SERVICE BULLETIN

APPLICABILITY: 2025MY Forester

NUMBER: 09-133-25

SUBJECT: DTC P0890, P0700, U0100,
U1120, & C1935 / Service Procedure

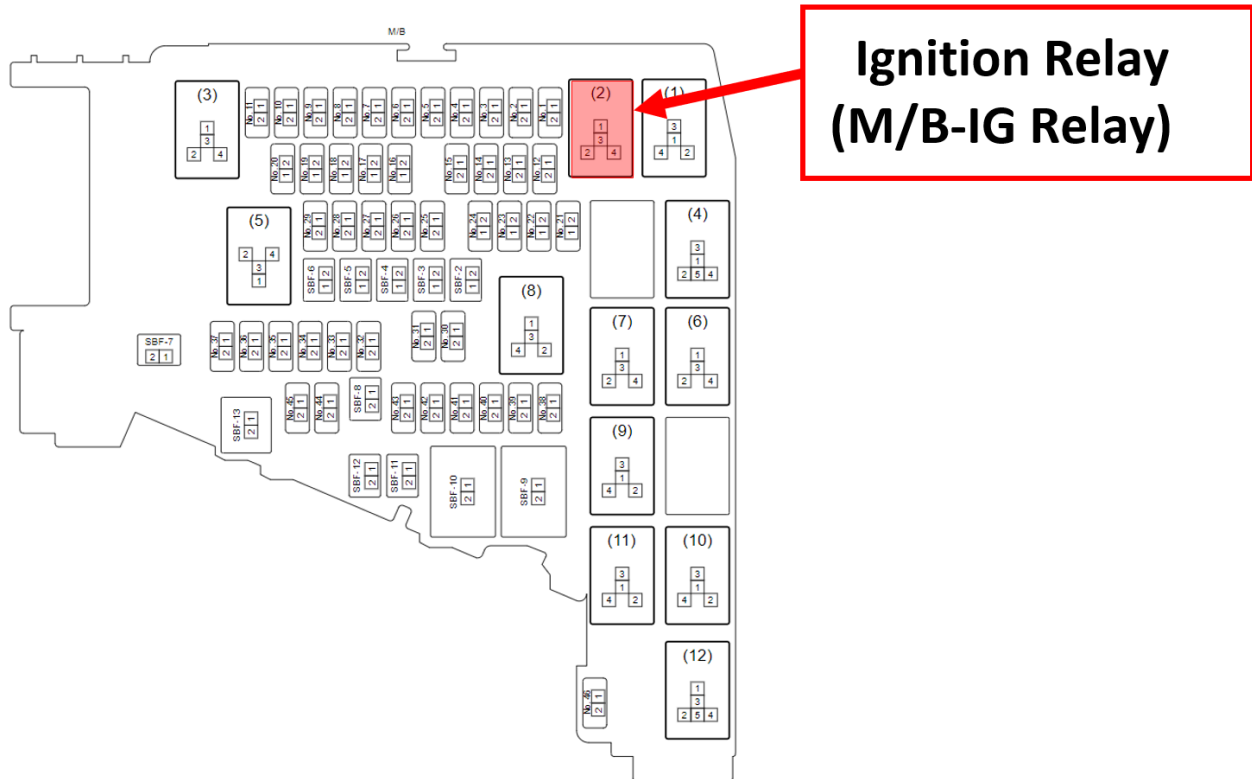
STEP 2: Inspect the ignition relay (M/B-IG Relay) located in the main relay box under the hood of the vehicle. See the judgement criteria below.

If the OLD **Brown** colored relay (p.n. 25232AA100) is currently installed, replace the relay with a NEW **Blue** colored relay (p.n. 25232KA050).

If the currently installed relay is the NEW **Blue** colored relay (p.n. 25232KA050), there is no need for relay replacement. The procedure is completed.

NOTE: The NEW **Blue** relay (p.n. 25232KA050) is **ONLY** to be used in this location and is not to be interchanged with other relays.
